**ADDENDUM NUMBER 7**

- 1.01 DATE: JANUARY 29, 2021**
- 1.02 PROJECT: ELMORE SPORTS MEDICINE RENOVATIONS**
- 1.03 PROJECT NUMBER: DCM NO. 2020452; PSCA NO. 2018**
- 1.04 OWNER: ALABAMA A&M UNIVERSITY**
- 1.05 ARCHITECT: NOLA | VAN PEURSEM ARCHITECTS, PC**

## MECHANICAL PLATFORM

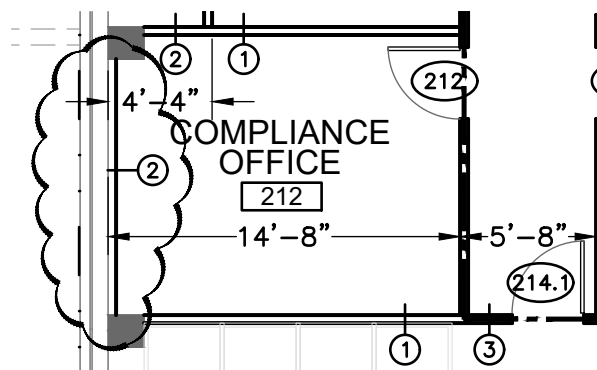
- A. See attachment AD7-A1.2-01 for revisions to 4/A-1.2 Mechanical Platform and 1/A1.2 Partial Mezzanine Plan at Compliance Office 212. Revisions include the following:
  - 1. Added Wood Guardrail (see next line item regarding Guardrail Detail)
  - 2. Added metal stud wall to west wall of Compliance Office 212.
- B. See attachment AD-A1.2-02 for Guardrail Detail.
- C. Remove and replace existing approximately 2'-0"x4'-0" transom window lite at (4) locations calling for mechanical louvers, with insulated metal panel, coordinate location with architect and mechanical drawings. Finish to match existing window frame.

SHEET TITLE  
**ELECTRICAL  
LOW VOLTAGE  
PLAN**

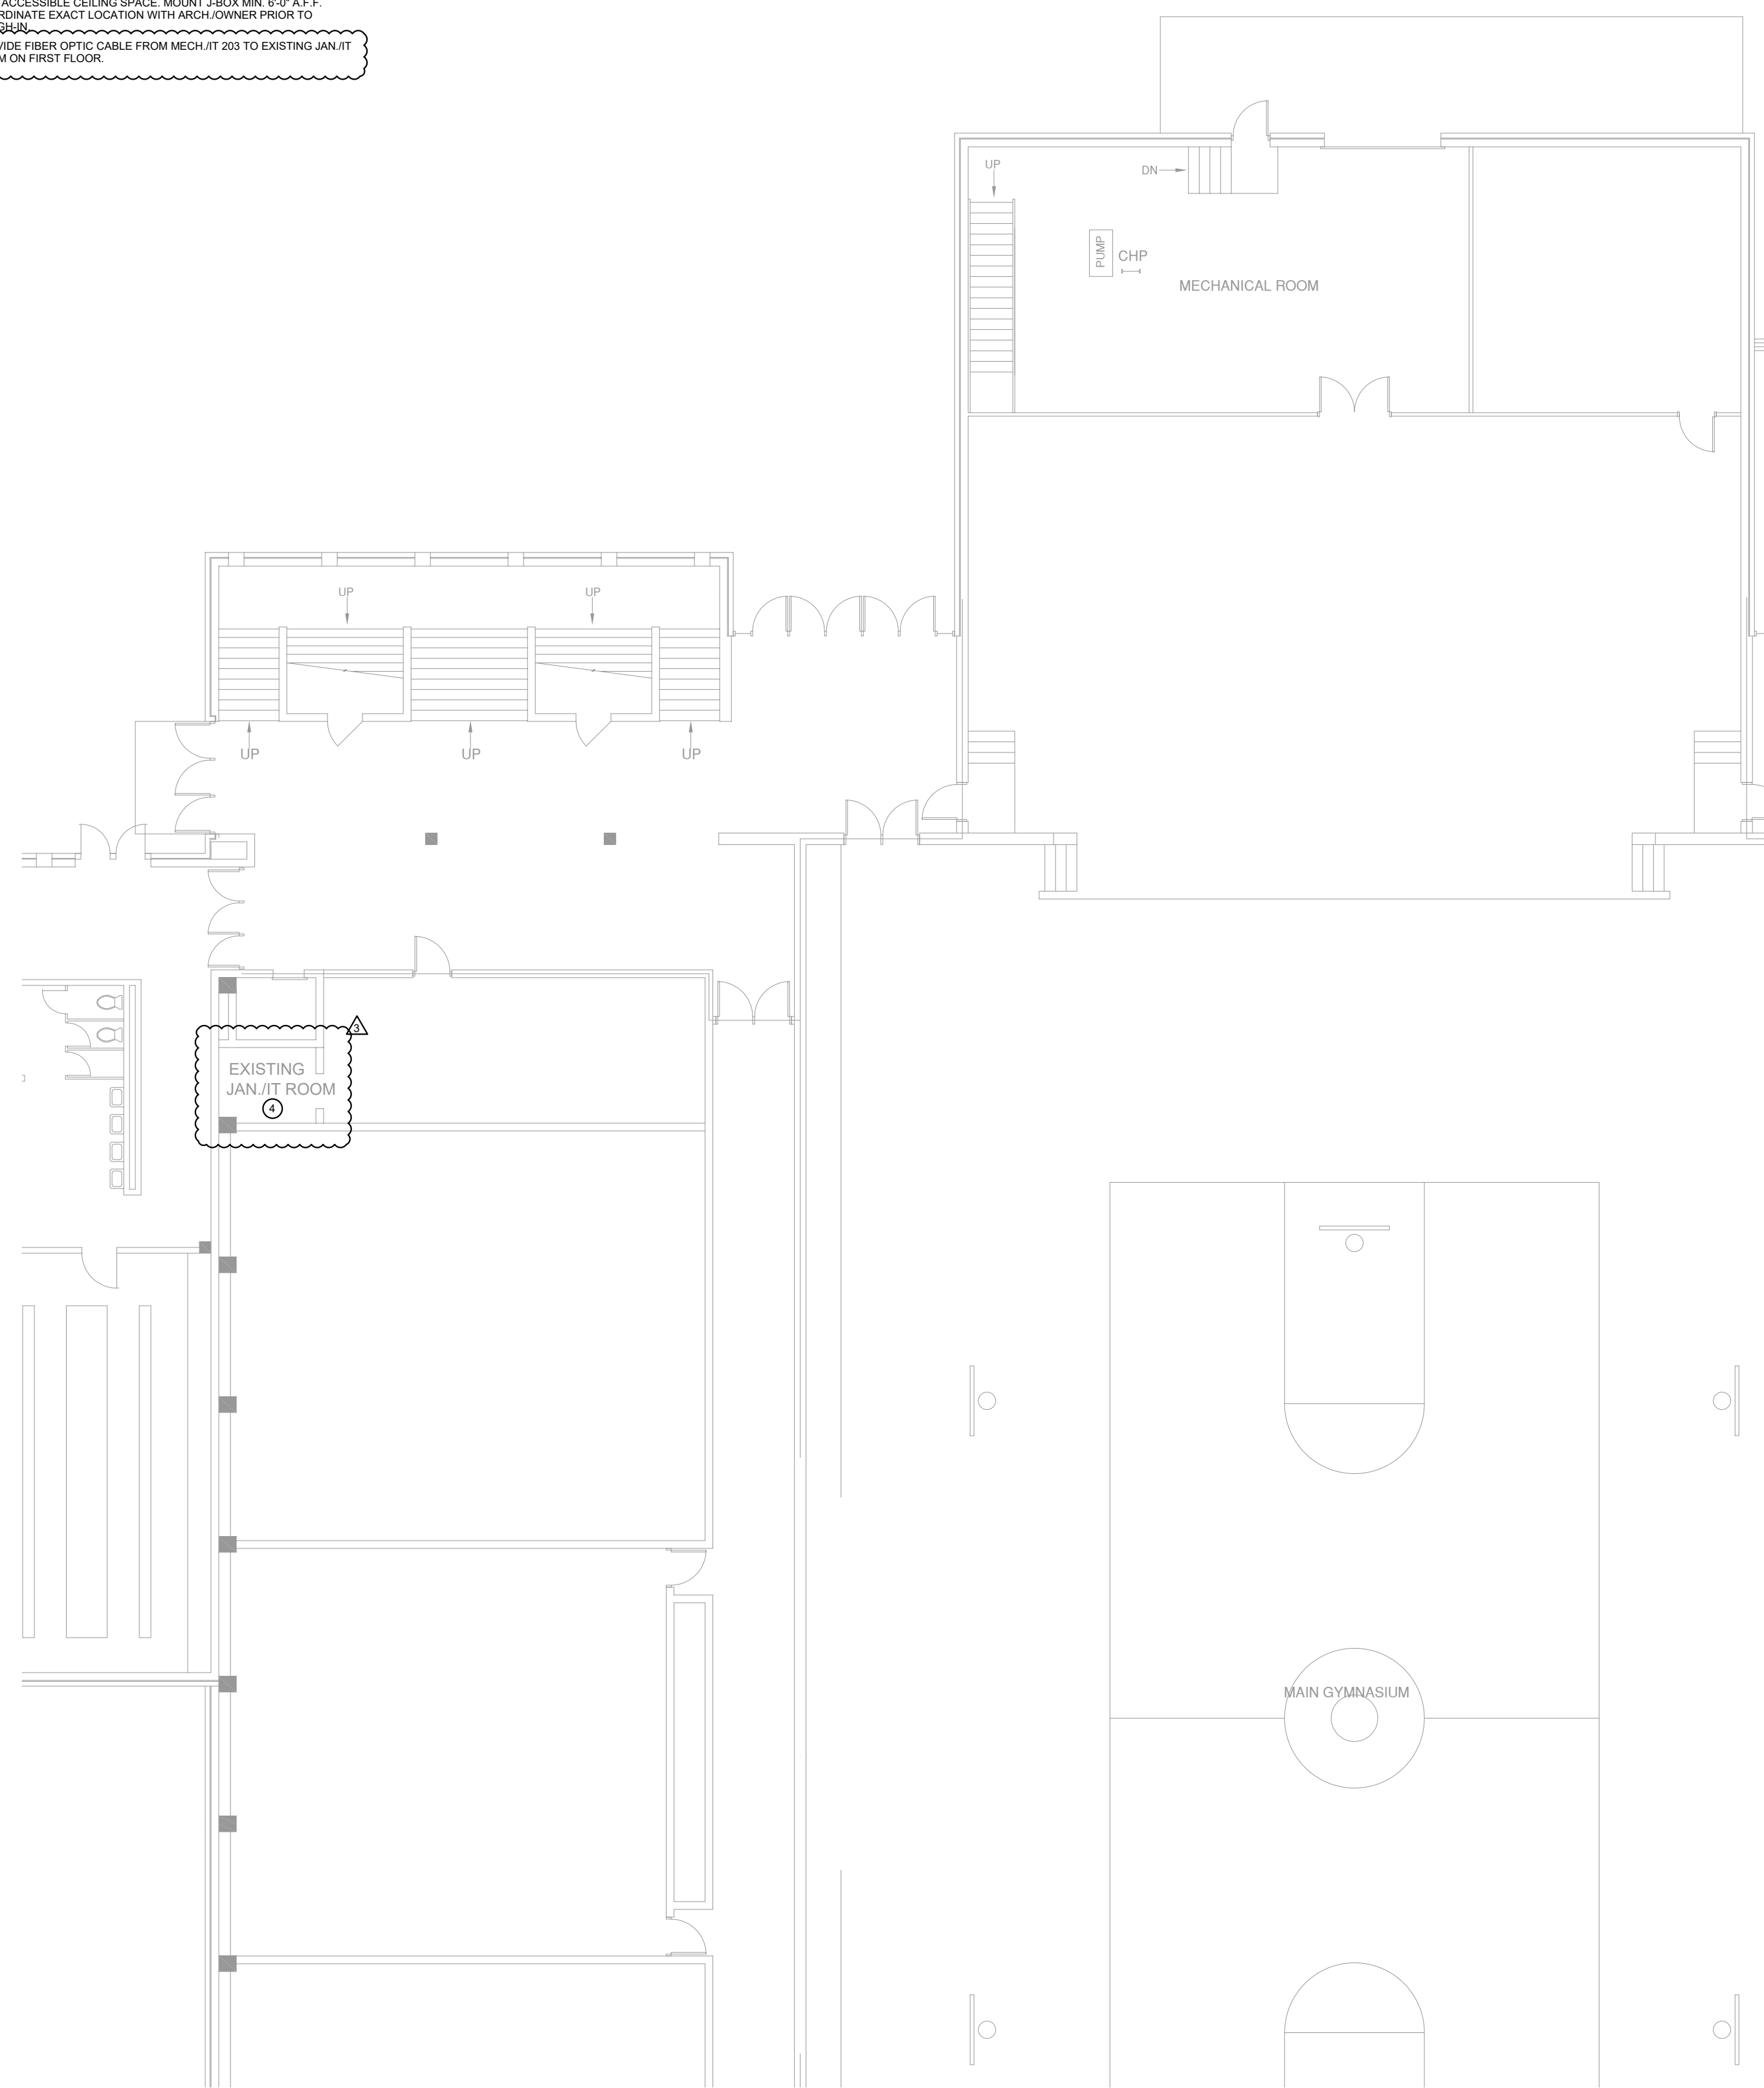
- A. Replace this sheet in its entirety. Revisions include the following:
  - 1. Added location of it room on first floor and second floor.
  - 2. Added Telecommunications Backboard in Mech./IT 203.
  - 3. Added Low Voltage General Notes.
  - 4. Added Low Voltage Keyed note #4, to provide fiber optic Cable between existing Jan./IT room (1st floor), and Mech./IT Room 203 (second Floor).
